**From:** Kerry Nash - KN Planning  
**Sent:** 1/03/2023 3:06:38 PM  
**To:** Council Northernbeaches Mailbox; Alexander Keller  
**Cc:** James Lloyd  
**Subject:** TRIMMED: Objection to Amended DA 2022-1164 on behalf of  
Apartment 633 Peninsula Building  
**Attachments:** KN59006 Objection to Amended DA2022-1164 34-35 South Steyne  
Manly 1.03.23 (Unit 633)..pdf;

Ref: KN590/06

**Re: Development Application No DA2022/1164  
34-35 South Steyne Manly  
Objection to amended proposal**

Viewpoint 01

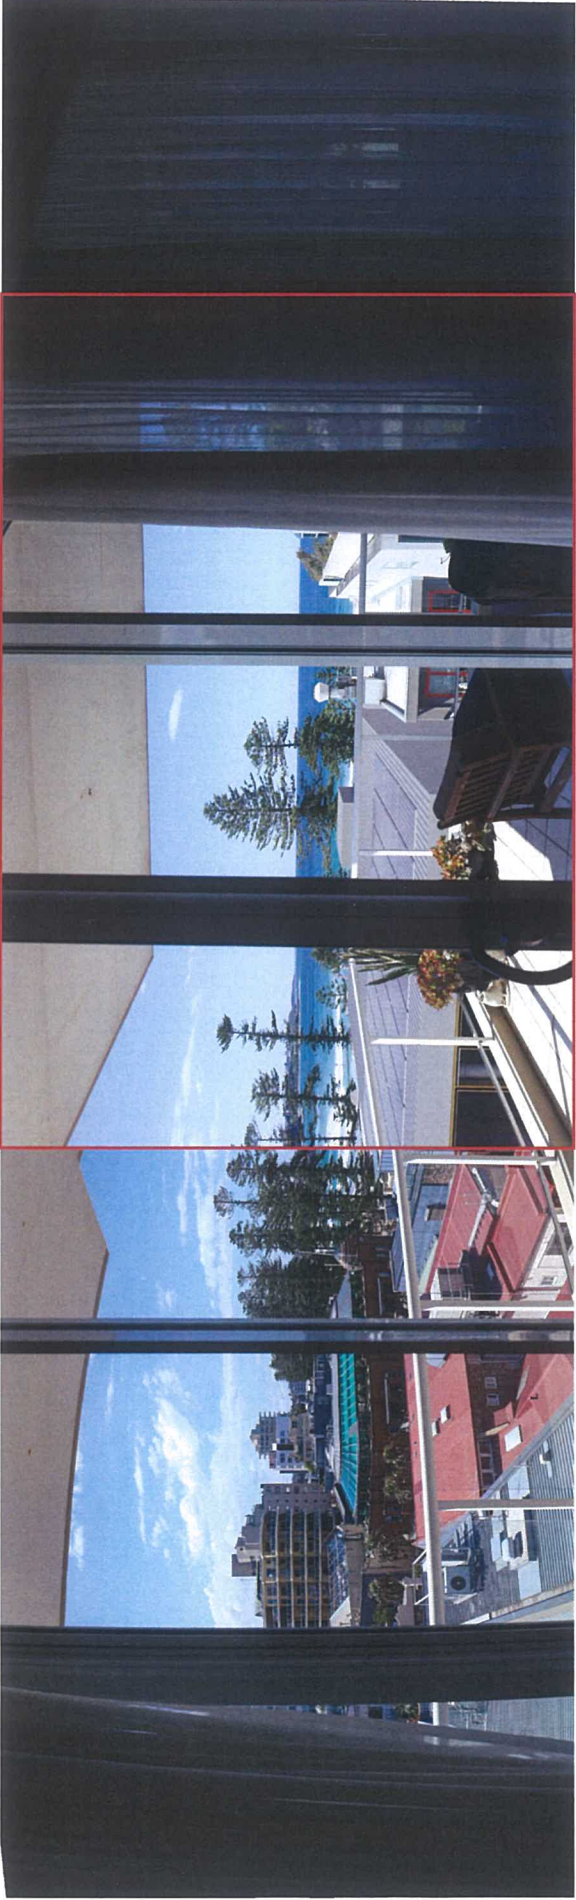
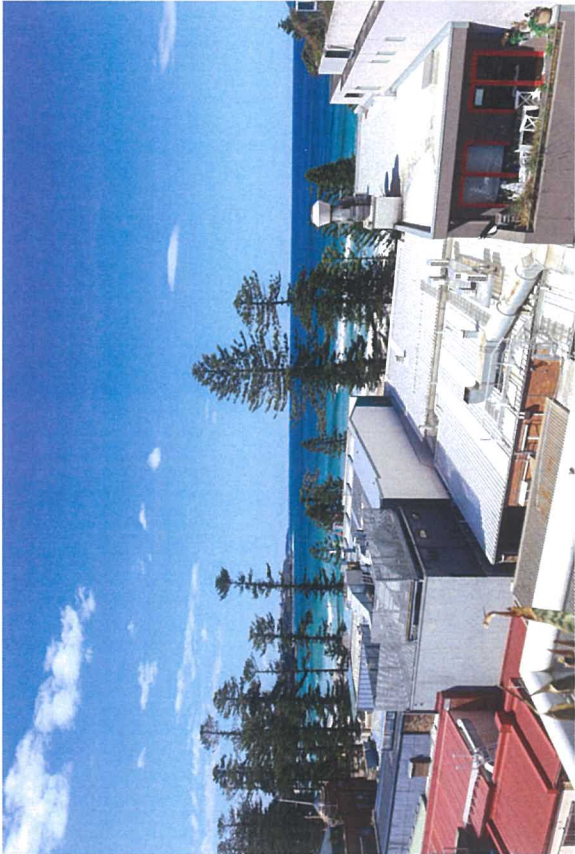
The View Loss Assessment, in particular Viewpoints 01, 02 and 05 confirm the view loss assessment undertaken in accordance with the planning principle in *Tenacity Consulting v. Warringah Council [2004] NSWLEC 140*, embodied in my objection of 17 August 2022, namely:-

*Balcony* – loss of land and water interface with South Steyne/Manly Beach at high and low tide and the lower portions of Norfolk Island Pines along South Steyne (*Photograph 4*). The Central Stair and elevated lap pool on the roof at RL17.00 also impacts on this view as evident in View 01 and 02.

*Living Room* – 100% loss of land and water interface of Manly Beach as detailed in Viewpoints 01, 02 and 05. Distant views of Tasman Sea retained - impact severe for the reasons detailed above.
